Re: Onondaga Lake Capping, Dredging, Habitat and Profundal Zone (SMU 8) Final Design, Modified Protective Cap RA-B1 Design Revision, Dated November 2015

**ONONDAGA LAKE CAPPING, DREDGING,
HABITAT AND PROFUNDAL ZONE (SMU 8)
FINAL DESIGN**

**MODIFIED PROTECTIVE CAP RA-B-1
DESIGN REVISION**

SUMMARY OF DESIGN REVISION

Figure 1
 Modified Protective Caps
 Remediation Area B
 Onondaga Lake

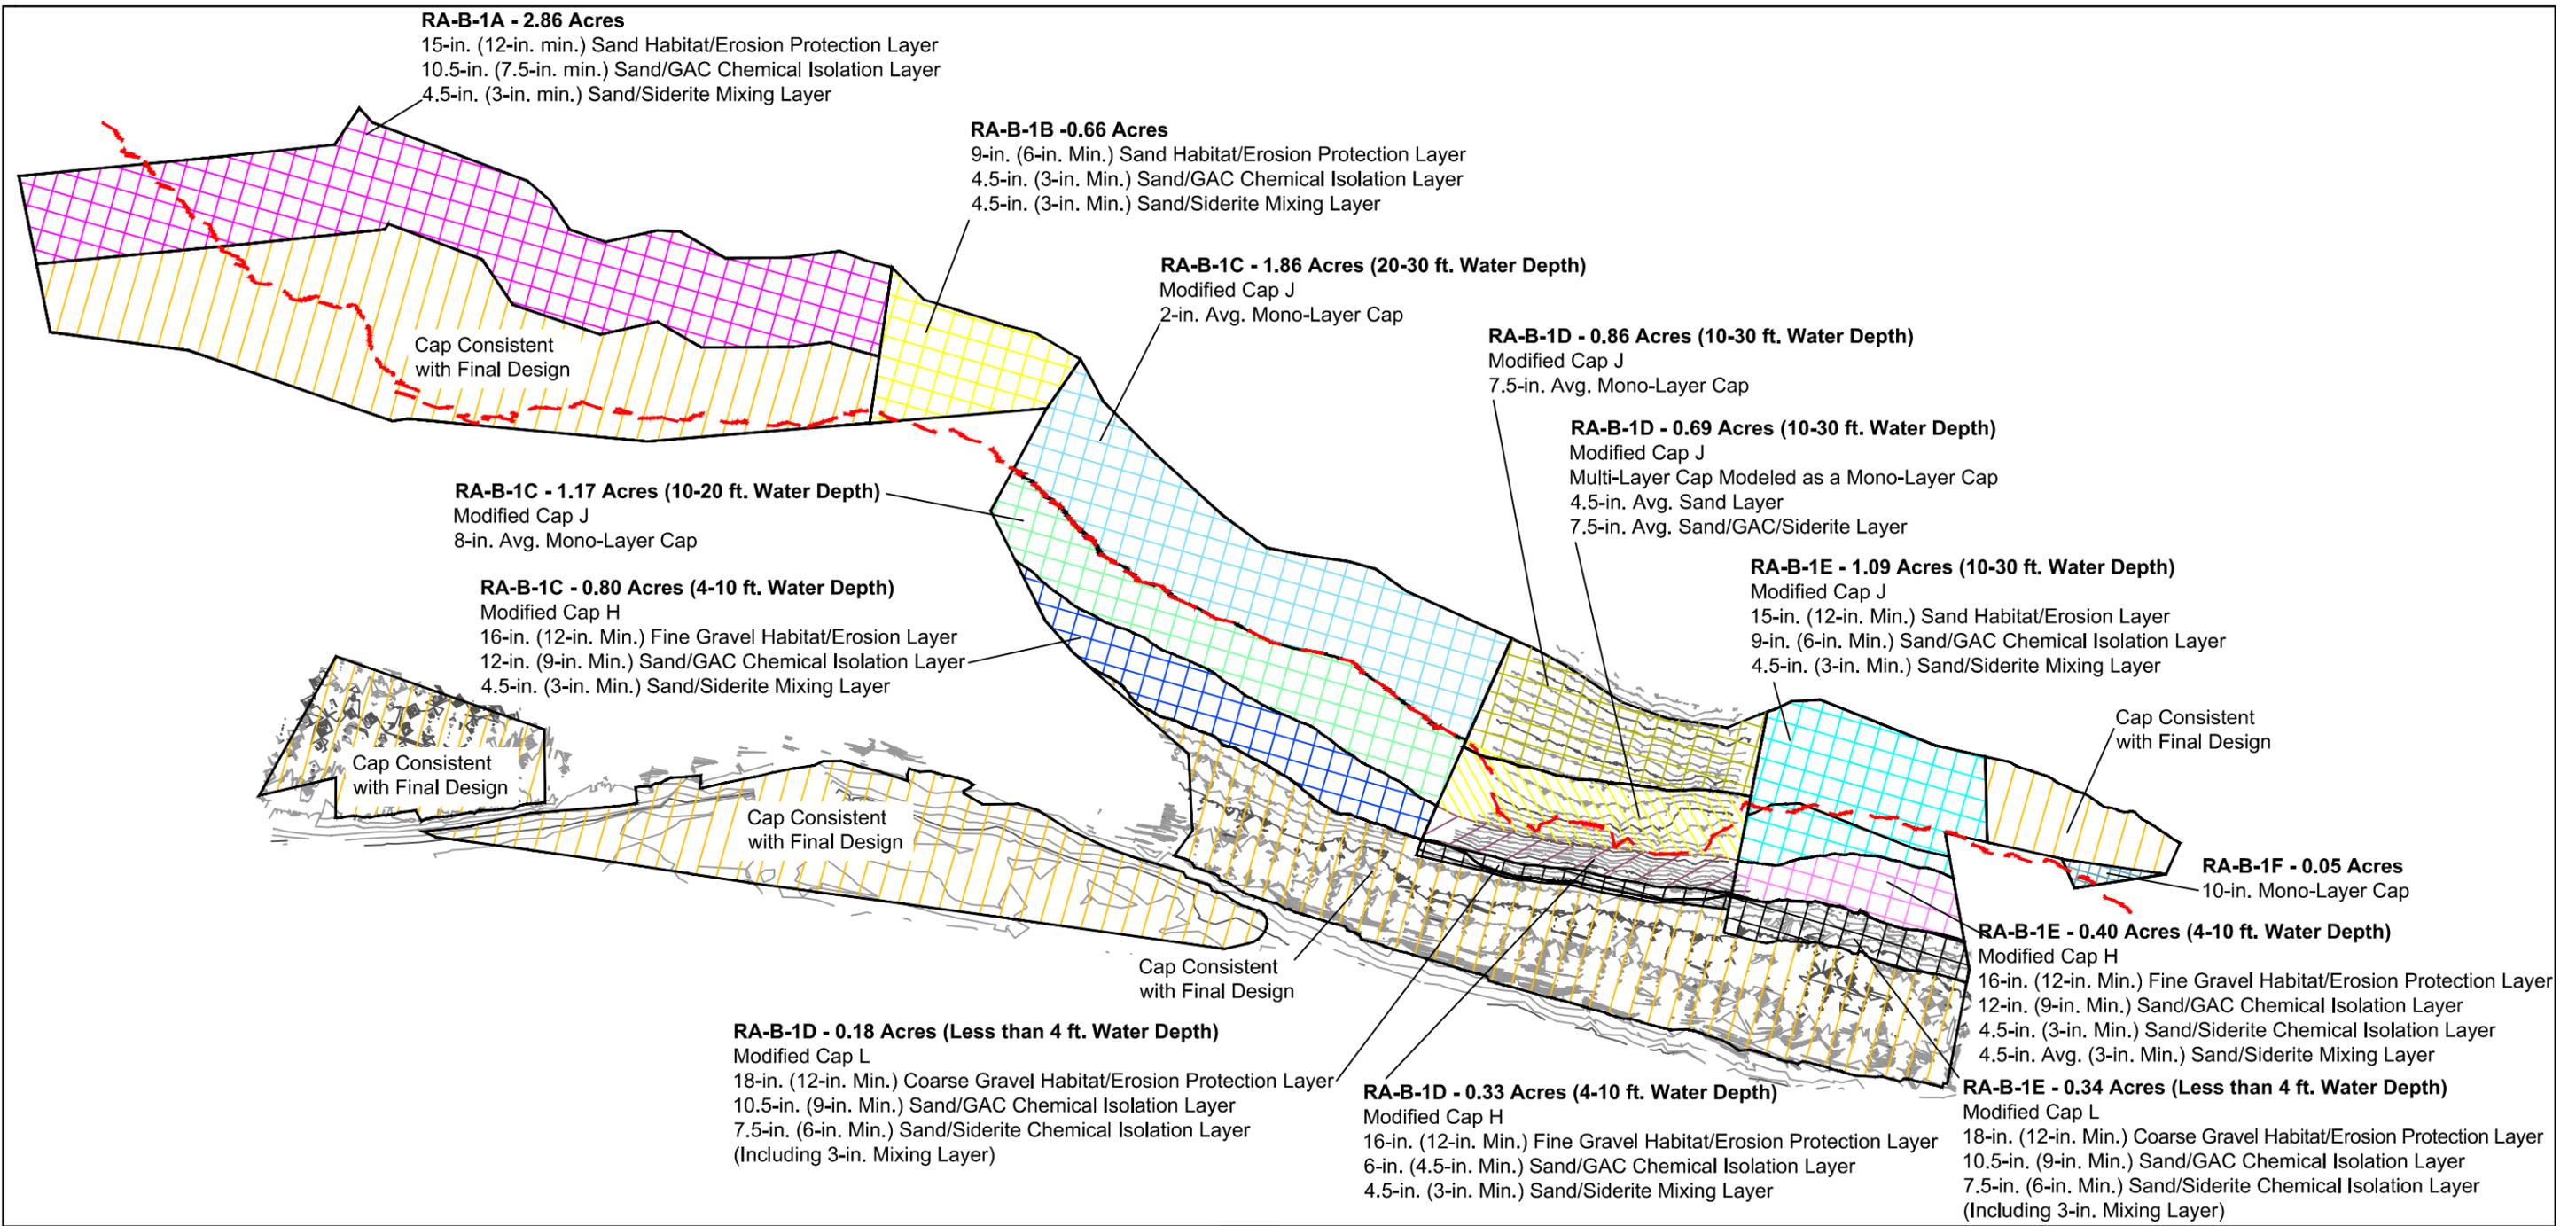
This cap design revision pertains to a portion of Remediation Area B (RA-B) where geotechnical investigations completed subsequent to the Final Design identified soft (low strength) sediment on relatively steep slopes. These sediments are softer than was identified during the Pre-design Investigation (PDI), and therefore a design revision is required in this area. For a capping project of the scale of Onondaga Lake Remediation, it is not unusual to expect to incur field conditions in minor areas throughout the implementation that may require adjustments to the cap system to achieve the remedial goals for the project. As discussed below, the various modified protective caps (MPC) in these areas will be protective for more than 1,000 years, consistent with the evaluation timeframe used in the final design.

The Modified Protective Cap (MPC) designs shown in Figure 1 were determined to be stable based on substantial geotechnical data collected following the movement and detailed geotechnical analysis, as presented in Attachment 1. The thickness and composition of the various layers comprising the MPCs are shown below as well as on Figure 1. Chemical isolation modeling was completed to determine the granular activated carbon (GAC) application rates that will be protective for more than 1,000 years, consistent with the evaluation timeframe used in the final design, as documented in Attachment 2. The updated GAC application rate based on this modeling are also listed below.

RA-B-1A (Multi-layer Cap) - GAC application rate of 1.29 lbs/sf

- 12-inch minimum sand habitat/erosion protection layer
- 7.5-inch minimum sand/GAC chemical isolation layer
- 3-inch minimum sand/siderite mixing layer

RA-B-1B (Multi-layer Cap) - GAC application rate of 1.30 lbs/sf

- 6-inch minimum sand habitat/erosion protection layer
- 3-inch minimum sand/GAC chemical isolation layer
- 3-inch minimum sand/siderite mixing layer

RA-B-1C (4 to 10 feet) (Multi-layer Cap) - GAC application rate of 0.61 lbs/sf

- 12-inch minimum fine gravel habitat/erosion protection layer
- 9-inch minimum sand/GAC chemical isolation layer
- 3-inch minimum of sand/siderite mixing layer

RA-B-1C (10 to 20 feet): (Mono-layer Cap) - GAC application rate of 0.49 lbs/sf

- 8-inch average sand/GAC/siderite

RA-B-1C (20 to 30 feet) (Mono-layer Cap) - GAC application rate of 0.49 lbs/sf

- 2-inch average sand/GAC/siderite

Figure 15. Recommended cap placement in modified protective cap area RA-B-1

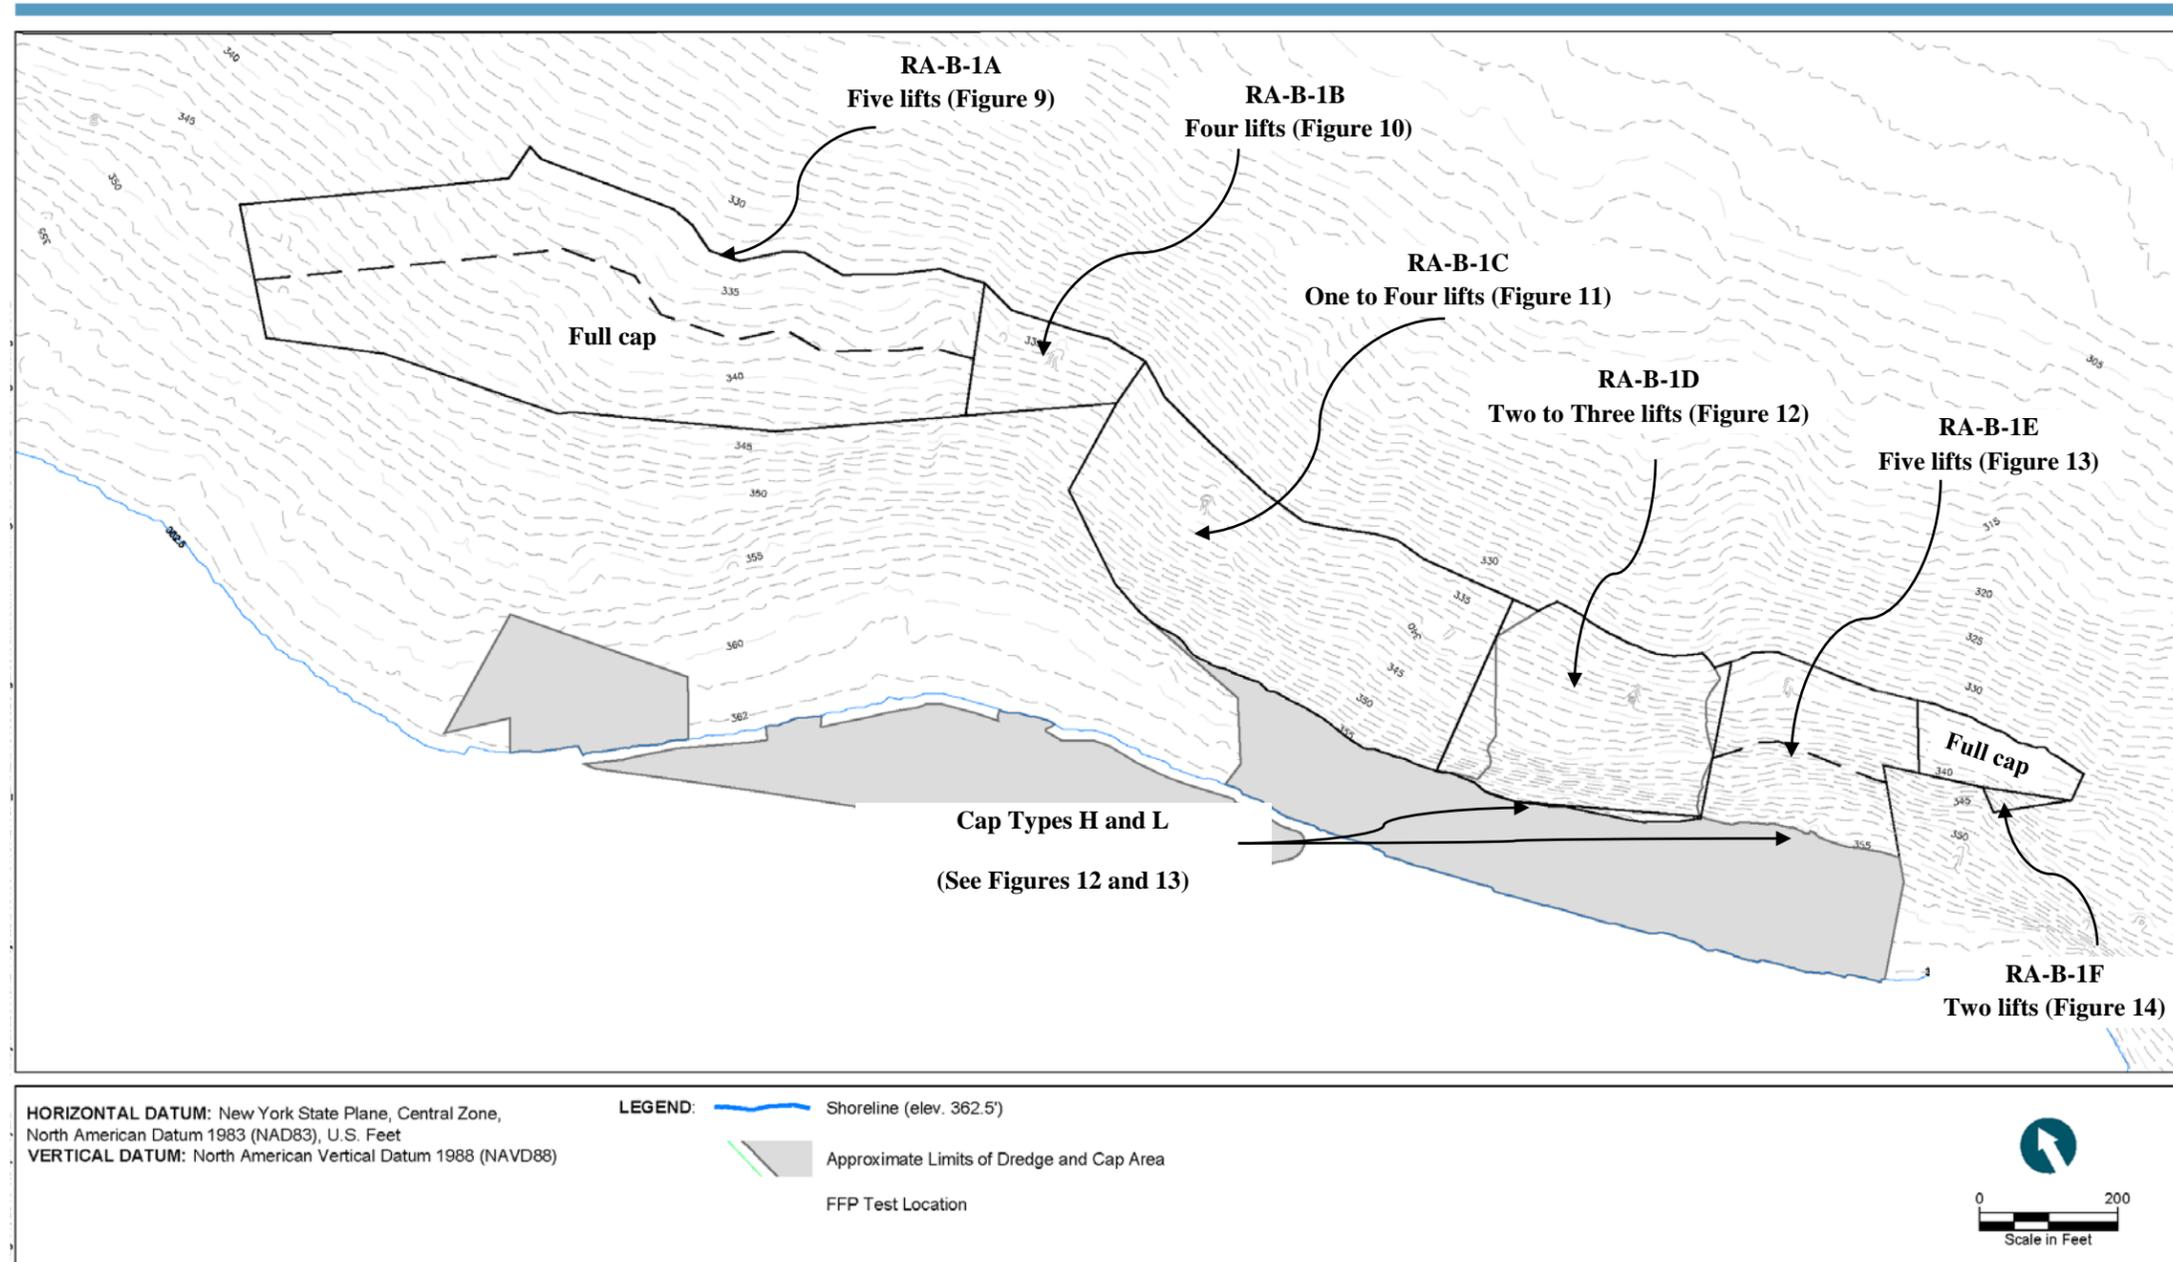
Figure 15 shows the recommendation for cap placement in the modified protective cap area RA-B-1.
